NEW RESIDENCE

1385 HILLSIDE CIRCLE, (LOT 3) BURLINGAME, CA
A.P.N.: 000-000-000

ARBORIST REPORT

SITE DEMOLITION PLAN
SCALE: 3/32"=1'-0"

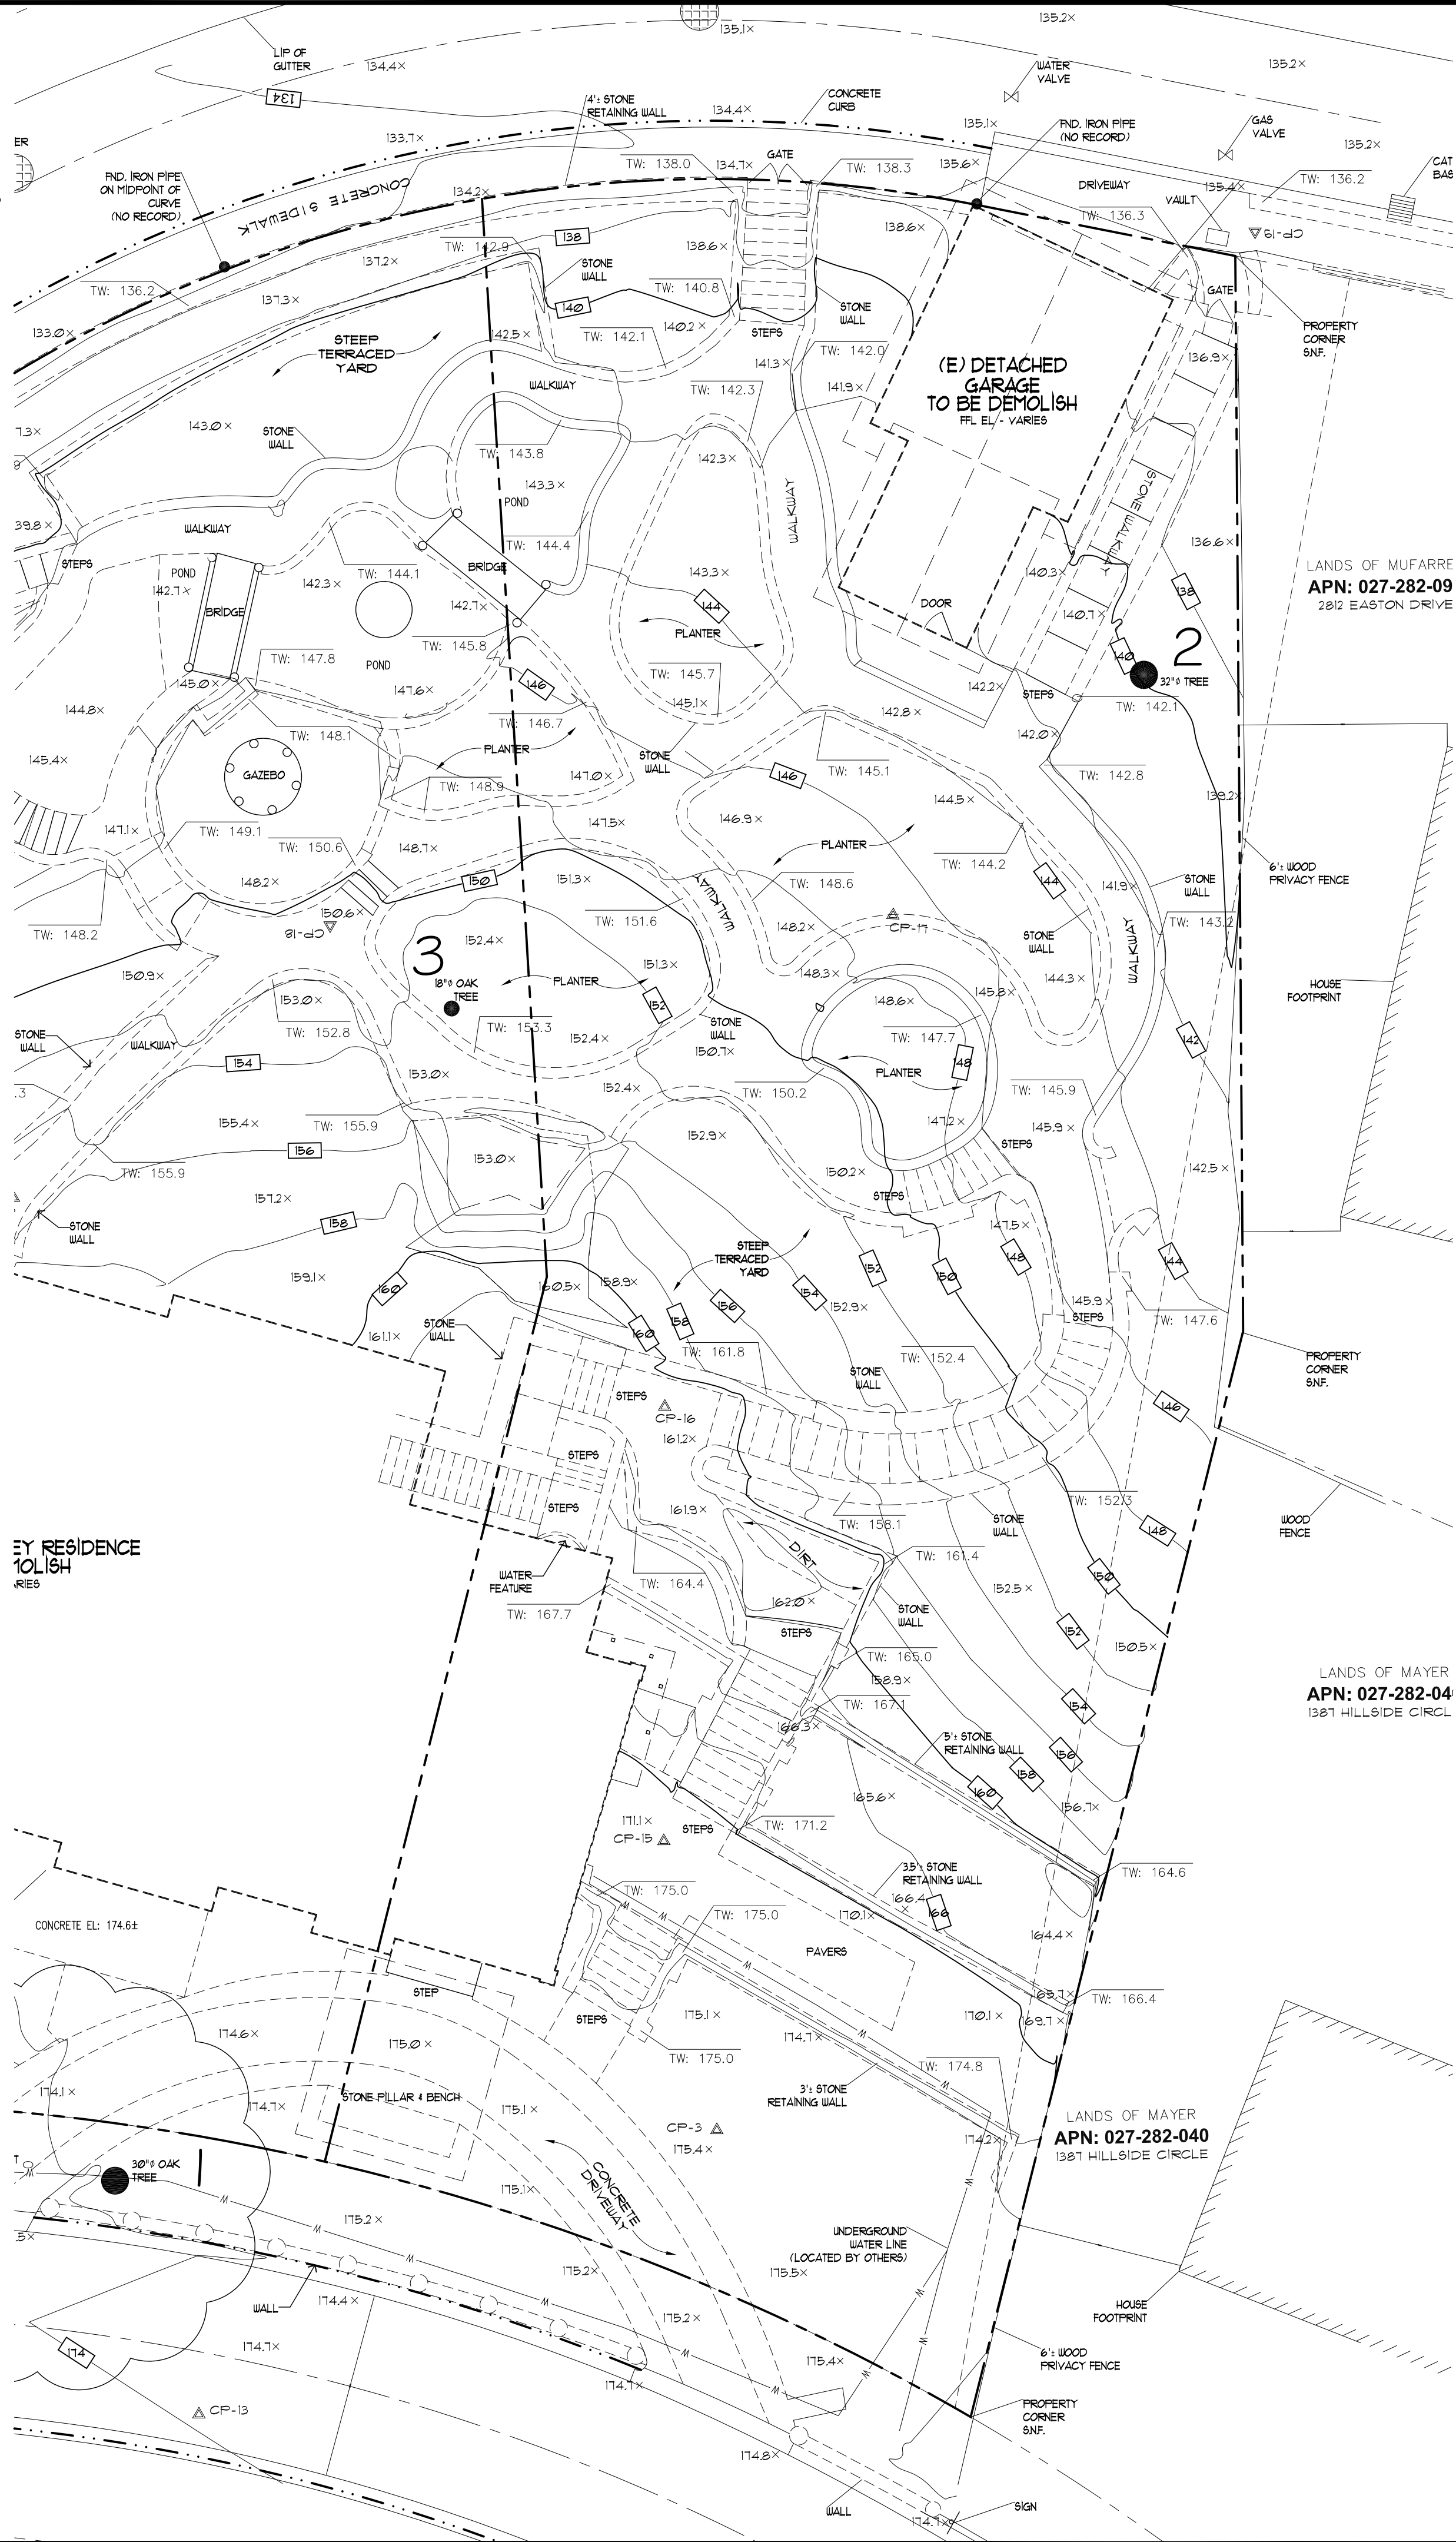
ENSURE THAT TREE PROTECTION SPECIFICATIONS ARE SHOWN GRAPHICALLY ON SITE PLANS FOR CONTRACTOR TO FOLLOW, AS FOLLOWS:

LOCATION OF ALL TREE PROTECTION MEASURES INCLUDING BUT NOT LIMITED TO FENCING, TRUNK WRAP, ROOT BUFFER, ARE TO BE GRAPHICALLY SHOWN ON DEMO PLAN A2 SO THAT CONTRACTOR CAN EASILY INSTALL AND EXECUTE THE TREE PROTECTION MEASURES.

LOCATIONS OF HAND DIGGING AND LOCATIONS OF WORK TO BE UNDER PROJECT ARBORIST SUPERVISION ARE TO BE GRAPHICALLY SHOWN ON THE RELEVANT SITE PLAN SO THAT CONTRACTOR(S) CAN EASILY UNDERSTAND AND EXECUTE THE SPECIFICATIONS. WORK WITH THE PROJECT ARBORIST TO PRODUCE ACCURATE INFORMATION ON THE RELEVANT SITE PLAN. SOME OF THE INFORMATION WILL BE ON THE A SHEETS AND SOME ON THE L SHEETS.

ARBORIST REPORT RECOMMENDS:
RETAINING SOME OF THE DRIVEWAY NEAR TREE 1 AND BREAKING IT DOWN BY HAND LATER IN THE PROJECT. PUT THIS ON DEMO PLAN A2 SO CONTRACTOR CAN FOLLOW IT.
CHANGING THE PATHWAY NEAR TREE 10 TO AVOID ROOT LOSS/DAMAGE. WHERE IS TREE 10? HAS THE PATHWAY BEEN CHANGED?

ARBORIST REPORT IS BASED ON REVIEWING L PLANS DATED JAN 2024, LOT 1 A PLANS DATED 10-26-22, LOT 2 A PLANS DATED 10-26-21 AND LOT 3 A PLANS DATED 10-26-21. NO CIVIL PLANS REVIEWED. NOTE THAT THE CONTENT OF CIVIL PLANS MAY NECESSITATE A CHANGE IN THE ARBORIST RECOMMENDATIONS.

INDICATE THAT AT LEAST 3 SINGLE-TRUNKED LANDSCAPE TREES WILL BE PRESENT ON EACH LOT, AS NOTED BELOW.
PER CHAPTER 11.06, THIS PROJECT REQUIRES 3 SINGLE-TRUNKED LANDSCAPE TREES FOR LOT 3.
TREES MAY BE EXISTING OR NEW.
REQUIRED TREES MAY NOT BE FRUIT OR NUT TREES, PALMS, ITALIAN CYPRESS OR JAPANESE MAPLE.
REQUIRED TREES MUST HAVE A MATURE HEIGHT OF OVER 15 FEET.
ALL REQUIRED TREES MUST BE IN GOOD CONDITION AT THE FINAL ARBORIST INSPECTION.
STREET TREES DO NOT COUNT TOWARDS THE REQUIRED TOTAL.

PROVIDE THE BOTANICAL NAME (GENUS AND SPECIES) AND LOCATION OF THE REQUIRED LANDSCAPE TREES, AND WHETHER THEY ARE EXISTING OR NEW, FOR EACH LOT.
